APPLICATION NO.	· FILING DATE	FIRST NAMED INVENTOR	ATTORNEY DOCKET NO.	CONFIRMATION NO.
10/642,211	08/18/2003	Mevin S. Mogil	100570-00036	2229
ARENT FOX	7590 02/16/200 KINTNER PLOTKIN &	•	EXAM	INER
SUITE 400		,	EXAMINER EARLY, MICHAEL JACOBY ART UNIT PAPER NUMBER 3744	
	CTICUT AVENUE, N.' N, DC 20036-5339	w.		
	•

Application No.	Applicant(s)					
	10/642,211	MOGIL, MEVIN S.					
Office Action Summary	Examiner	Art Unit					
	Michael J. Early	3744					
The MAILING DATE of this communication app Period for Reply	pears on the cover sheet with t	he correspondence address					
A SHORTENED STATUTORY PERIOD FOR REPLY WHICHEVER IS LONGER, FROM THE MAILING D/ - Extensions of time may be available under the provisions of 37 CFR 1.11 after SIX (6) MONTHS from the mailing date of this communication If NO period for reply is specified above, the maximum statutory period v - Failure to reply within the set or extended period for reply will, by statute Any reply received by the Office later than three months after the mailing earned patent term adjustment. See 37 CFR 1.704(b).	ATE OF THIS COMMUNICATION ATE OF THIS COMMUNICATION AT THE ASSET OF TH	FION. be timely filed from the mailing date of thi

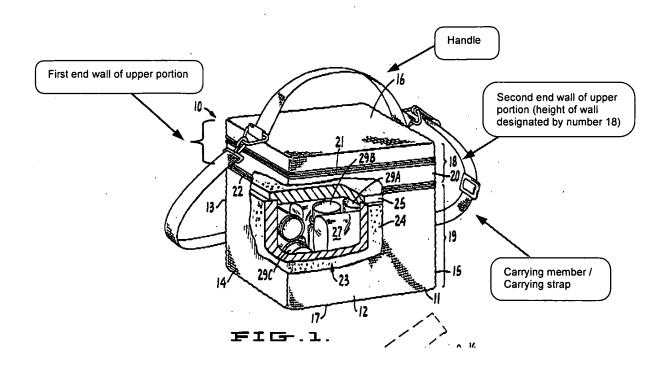
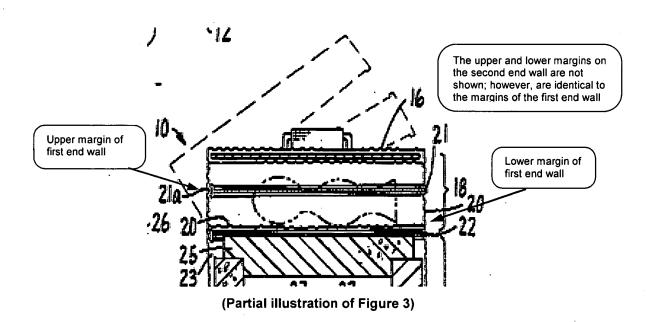
Regarding claim 36, Hank discloses an insulated lower portion (19 – lower compartment; col. 3, lines 35-46) and an upper portion (18 – upper compartment) (see col. 5, lines 33-36; Figures 2, 8); said lower portion having a rectangular base (17 – bottom panel) and rectangular side walls (12, 13, 14, 15 – front, back, side panels) standing upwardly therefrom (as seen in Figures 1, 3); said rectangular base having a

Regarding claim 37, Hauk discloses a handle by which to carry said container (as seen in the illustration of Figure 1 above), said handle being mounted to said wall (as seen in Figure 1).

Regarding claim 38, Hauk discloses said container has a center of gravity (obvious), and a carrying member (as seen in the illustration of Figure 1 above) is mounted to said container above said center of gravity (obvious).

Regarding claim 39, Hauk discloses a carrying strap is mounted to said upper portion of said container (as seen in the illustration of Figure 1 above).

(Partial illustration of Figure 2)

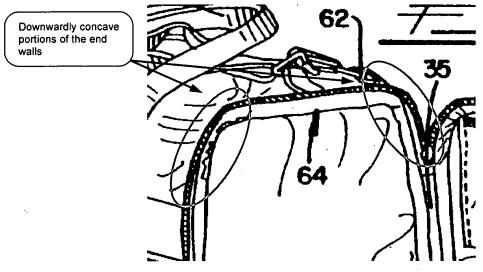
Applicant further argues that the end wall of Jacober ('526) can not fairly be characterized as being "downwardly concave." This argument is not persuasive. As seen in the partial illustration of Figure 2 below, the end walls of Jacober ('526) are shaped in a downwardly concave (i.e., rounded inward) manner. Furthermore, it would have been obvious to one of ordinary skill in the art at the time the invention was made to modify the existing apparatus of Hauk by incorporating end walls that have downwardly concave profiles, as taught by Jacober ('526), for aesthetic reasons, thus making the apparatus more appealing and marketable to consumers.
